## **COMPOUND W II SUBDIVISION**

APPLICATION NUMBER 10 DATE December 4, 2003

APPLICANT Compound W II

REQUEST Subdivision

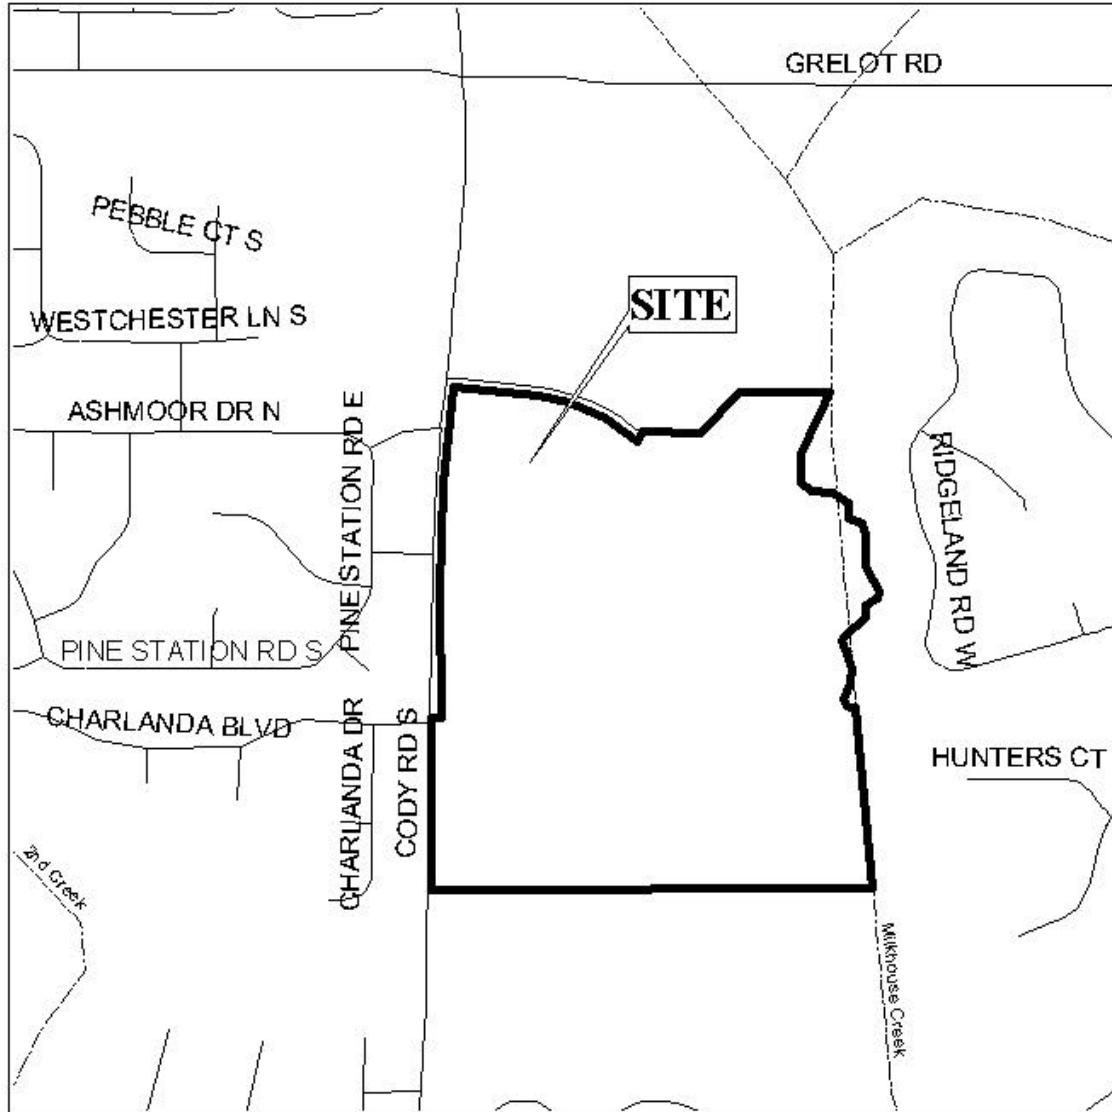
The plat illustrates the proposed 3 lot, 69 acre subdivision which is located at the Southeast corner of Cody Road and Bruns Drive. The site is served by public water and sanitary sewer.

The site fronts Cody Road, a planned major street and the right-of-way is illustrated as variable. Lot 1 will consist of an estate residence, not apartments; therefore, an additional setback to allow for the planned major street should be required. However, as Lot 2 is commercial property, the dedication of sufficient right-of-way to provide 50-feet from the centerline of the major street should be required. Moreover, the placement of a note on the final plat stating that the location, number and design of all curb cuts shall be approved by Traffic Engineering, should be required.

As illustrated on the Vicinity Map, the site is spilt zoned, thus the submission and approval of rezoning applications to eliminate the split zoning should be required prior to the issuance of a Certificate of Occupancy.

The site is adjacent to Milkhouse Creek, thus the area may be considered environmentally sensitive; therefore, the approval of all applicable federal, state and local agencies would be required.

With modifications, the plat will meet the minimum requirements of the Subdivision Regulations and is recommended for Tentative Approval subject to the following conditions: 1) the provision of an additional setback to provide 75-feet from the centerline of Cody Road (Lot 1); 2) the dedication of adequate right of way to provide 50-feet from the centerline of Cody Road (Lot 2); 3) placement of a note on the final plat stating that the location, number and design of all curb cuts shall be approved by Traffic Engineering; 4) the submission and approval of rezoning applications to eliminate split zoning prior to the issuance of a Certificate of Occupancy; 5) the approval of all applicable federal, state and local agencies; and 6) full compliance with City Engineering Comments (strict adherence to all stormwater ordinance requirements, provision of drainage easements to encompass 100 year flood area, compliance with all stormwater and flood control ordinances, any work performed in the right of way will require a right of way permit).
